ADDENDUM# 2

UK Indoor Track Facility

TRADE SCOPE CLARIFICATIONS Congleton – Hacker Company

The Addendum will form a part of the Contract Documents and modifies the original Bidding Documents dated October 2022.

S-204

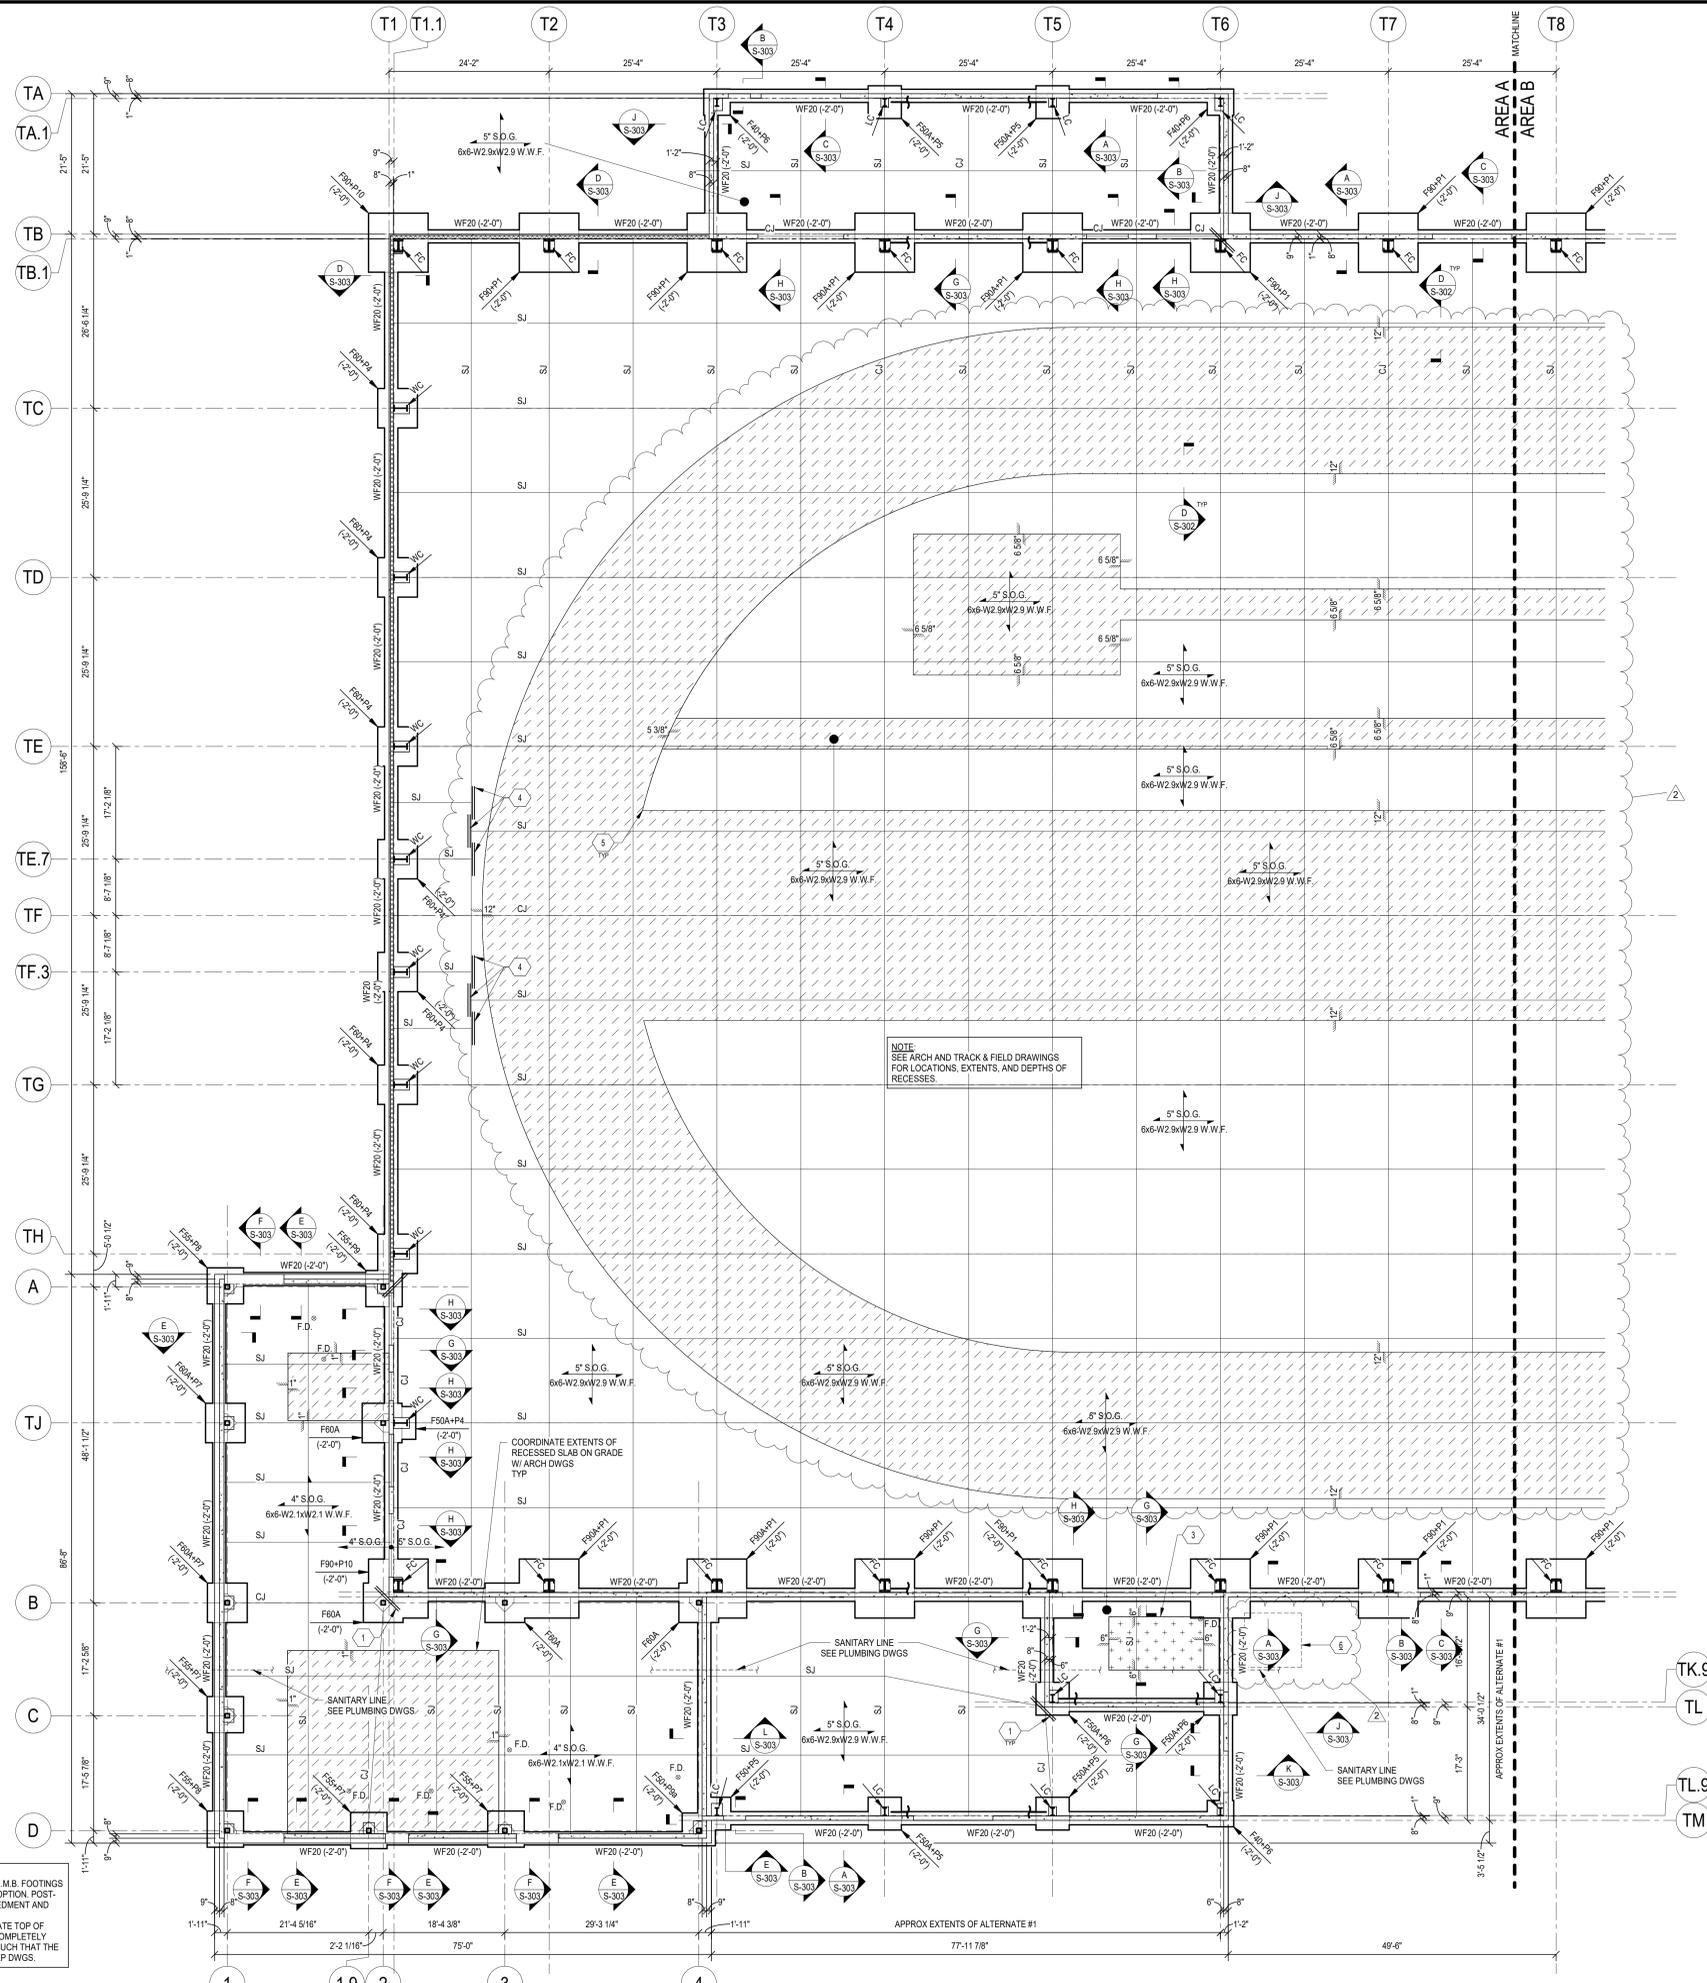
Refer to attached revised Sheets S-204 and S-205.

- Approximate extents, location, and depth of recess for track equipment added. Typical detail at recess cut on plan. Detail added on sheet S-302.
- Exterior mechanical unit indicated and tag note addressing slab on grade & housekeeping pad requirements added.
- Tag notes #5 and #6 added.

LOCATION, EXTENTS, AND DEPTH OF RECESSES FOR TRACK & FIELD EQUIPMENT TO BE COORDINATED WITH ARCH DRAWINGS AND TRACK & FIELD SHOP DRAWINGS, WHEN RECEIVED, AND MAY BE REVISED AT A FUTURE DATE.

INTERIOR ELEVATIONS AND DETAILS

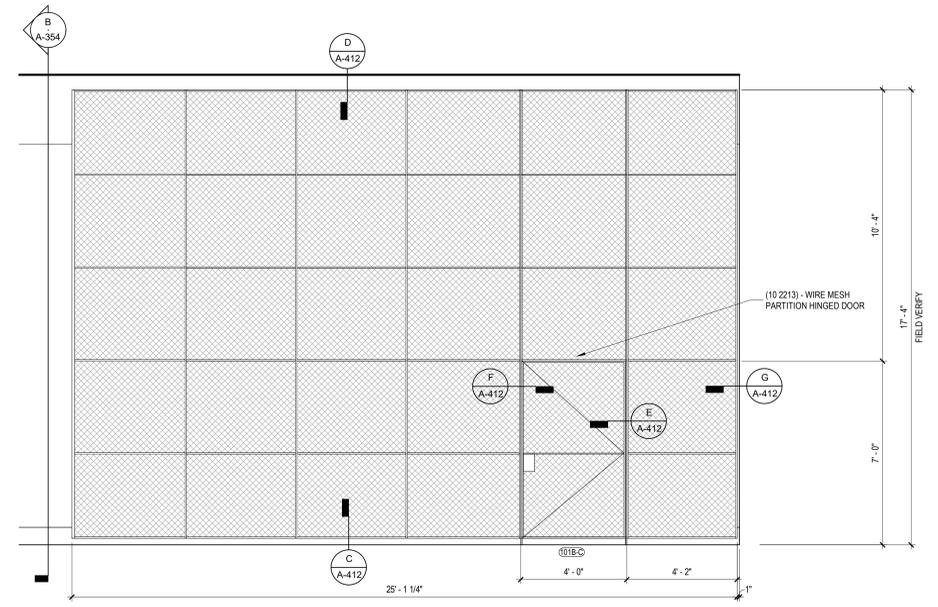
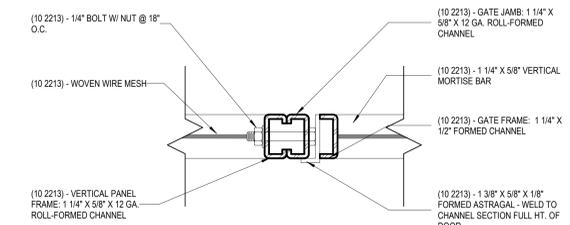
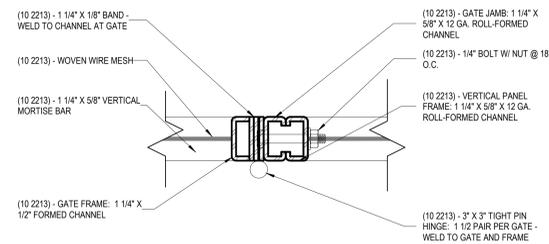
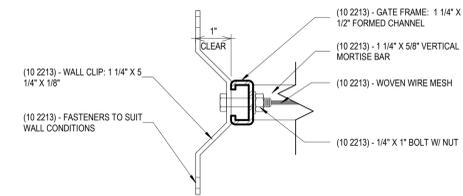
Refer to attached revised sheet A-412 Interior Elevations and Details. Coordinate wire mesh partition with metal building brace.

SECTION
E3 - BASE BID EXTERIOR WALL TYPE
1 1/2" = 1'-0"

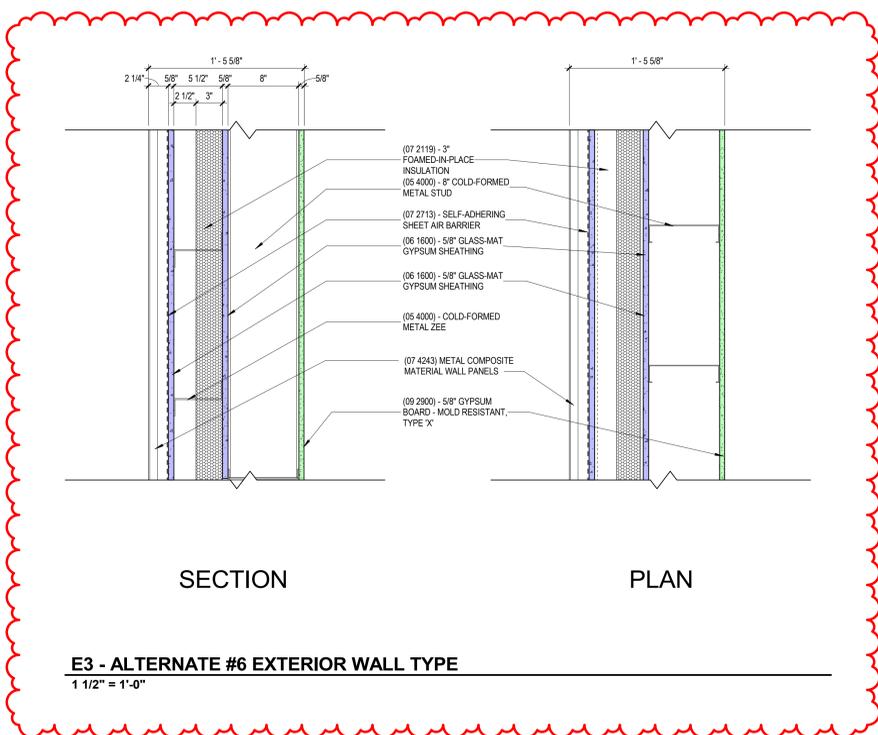
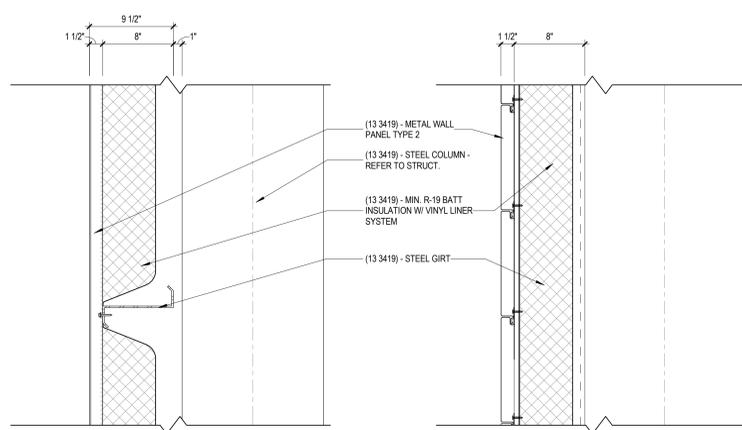
Refer to attached revised sheet A-501 Exterior Assemblies. Added tag for membrane air barrier to wall type E3. Added alternate detail for wall type E3 for Alternate No. 6.

Refer to revised sheet A-501 Exterior Assemblies, new Sheet A-534 Enlarged Section Details Base Bid, revised specification section 01 2300 "Alternates", and new specification section 07 4243 "Metal Composite Material Wall Panels", all attached to this Addendum.

Base Bid: Provide metal wall panel type 2 from MBM for exterior wall type E3

Alternate: Provide Metal Composite Material Wall Panels per 07 4243 for exterior wall type E3

ELECTRICAL SITE UTILITY PLAN

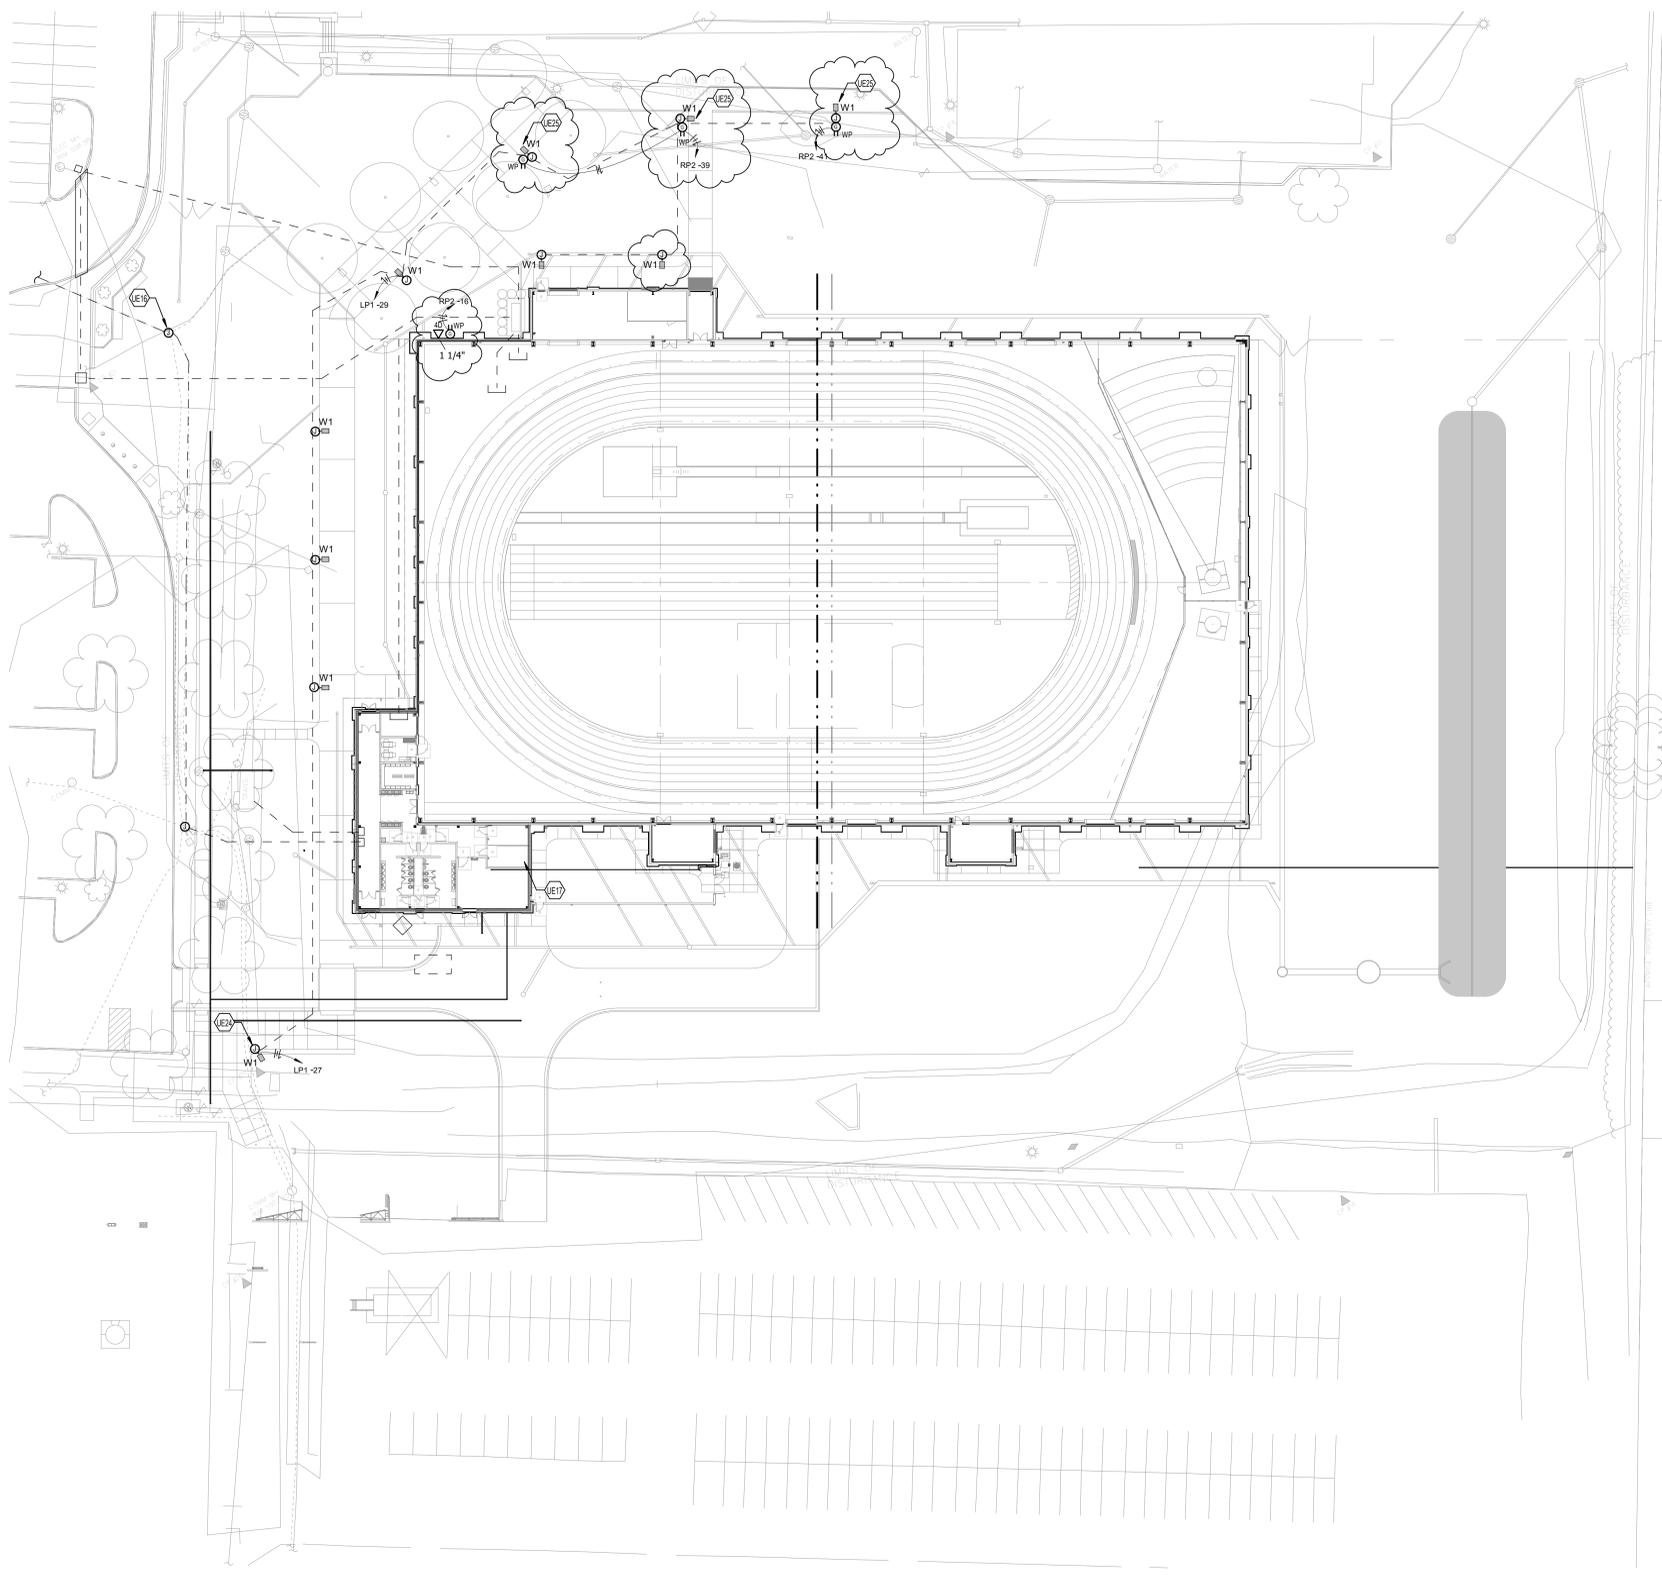
Refer to revised sheet EU-101– Electrical Site Utility Plan. Changed Light Pole locations. Added Weatherproof GFI Receptacles to base of noted light poles.

Refer to revised sheet EU-101, Electrical Site Utility Plan. Added Weatherproof GFI receptacle for ticketing purposes. Added data drop for ticketing purposes.

1 OVERALL PLUMBING PLAN
1/16" = 1'-0"

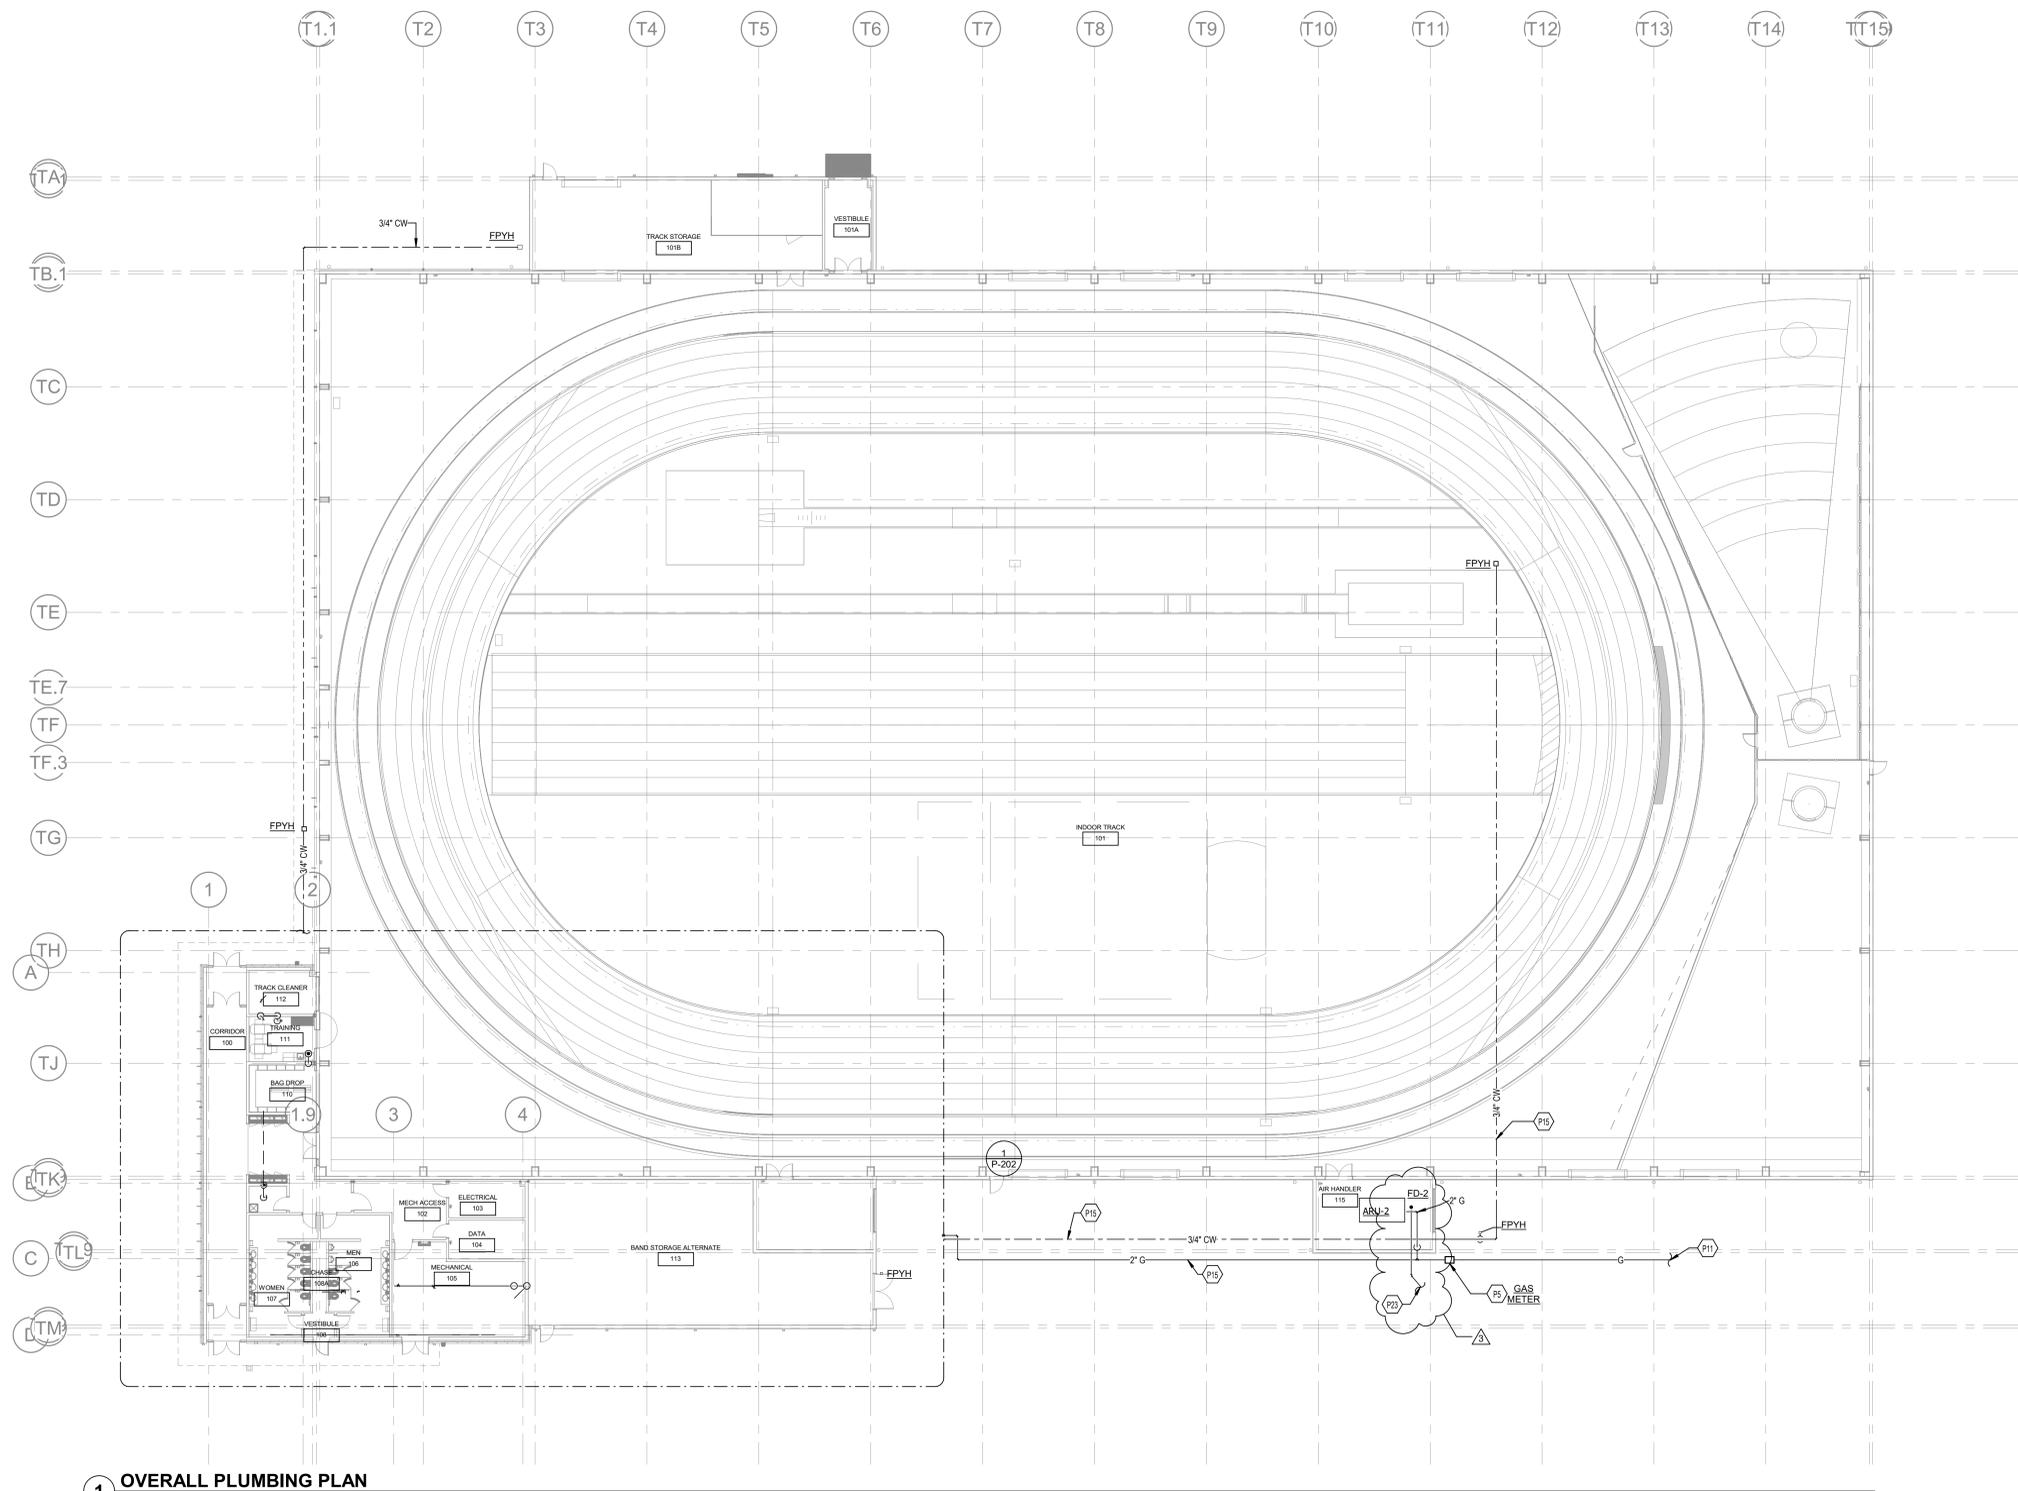
Refer to revised sheet P-201, Overall Plumbing Plan. Added piping from floor drain to storm. Added note P23.

- P5 COORDINATE GAS METER INSTALLATION WITH COLUMBIA GAS.
- P14 REFER TO PLUMBING OVERALL PLAN FOR CONTINUATION.
- P15 PIPING IS TO BE LOCATED UNDERGROUND.
- P23 CONNECT AIR HANDLER ROOM FLOOR DRAIN FOR CONDENSATE TO THE SITE STORM SEWER PIPING. REFER TO CIVIL PLAN C-201 FOR STORM PIPE ROUTING.
